REGULATIONS No. 55 (Mechanical couplings)

Proposal for amendments to Regulation No. 55

SK201341

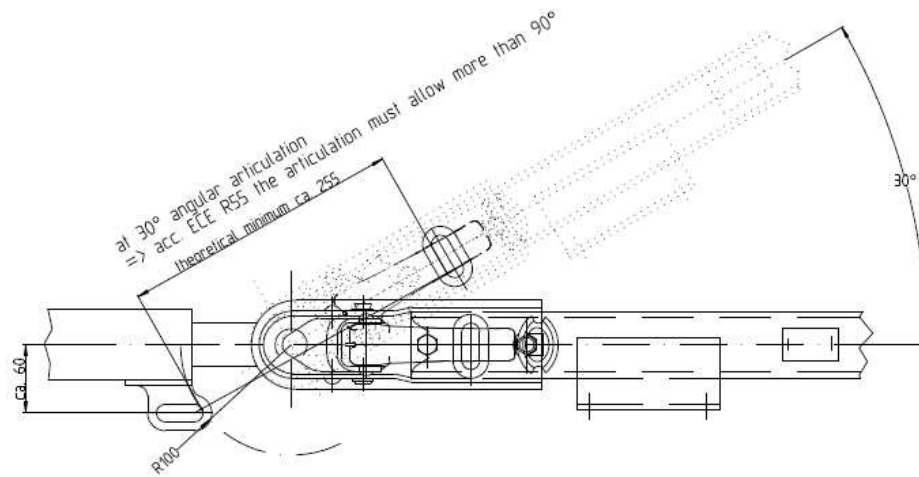
Plus extra 60mm for difference in height (siehe view above)  
=> resulting minimum length of safety device = 300mm

Sketch to determine the minimum length of the "Secondary coupling device" add. ECE R55

SK201342

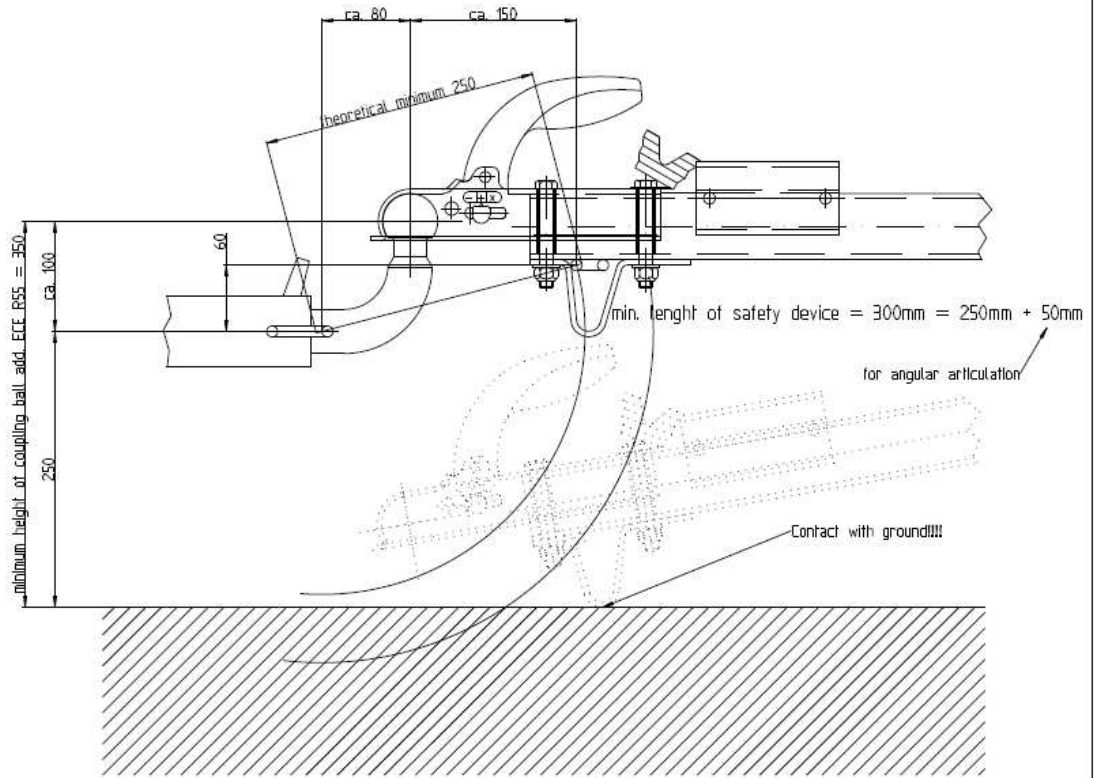
fixing point within a radi R100  
acc. figure B.2 of ISO/CD 12385

Plus extra 60mm for difference in height (siehe view above)  
=> resulting minimum length of safety device = 300mm

Sketch to determine the minimum length of  
the "Secondary coupling device" add. ISO/CD 12385
